OBJECTION - HORSLEY DRIVE BUSINESS PARK – STATE SIGNIFICANT DEVELOPMENT APPLCIATION 17161650

EXHIBITION OF EIS - HORSLEY DRIVE BUSINESS PARK STAGE 2 BUILDINGS 2 & 3 - CNR COWPASTURE ROAD & TRIVET STREET, WETHERILL PARK

Figure 1 – SSD 7664 Conditions of Consent

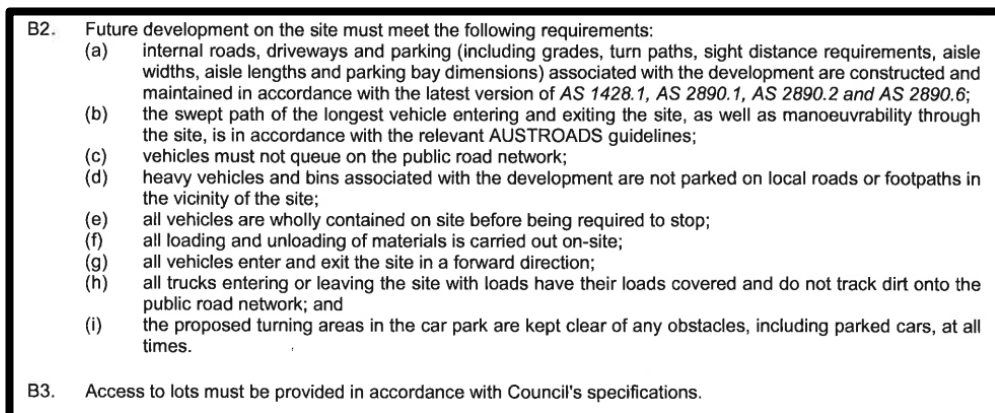
- a. A previous submission by Council (20 April 2021) identified the above identified concerns including potential traffic impacts from the development on the surrounding road network infrastructure, vehicle conflict on the external estate road due to the location of ingress and egress for warehouses 2 and 3 and heavy vehicle circulation in the northwest corner of Warehouse 3. These concerns are not addressed as part of the documentation submitted with the EIS.
- b. SSD 7664 forms the concept plan approval for stage 2 of the HDBP. Conditions B1 and B2 of the approval form requirements relating to traffic and access for the future warehouse 2 and 3 (see Fig 1 below).

It is clear from the EIS that vehicles would be required to stop prior to entering the site and that swept path diagrams submitted with the OTMP show heavy vehicles unable to manoeuvre out of the site without clashing. This forms non-compliance with the conditions of SSD 7664.
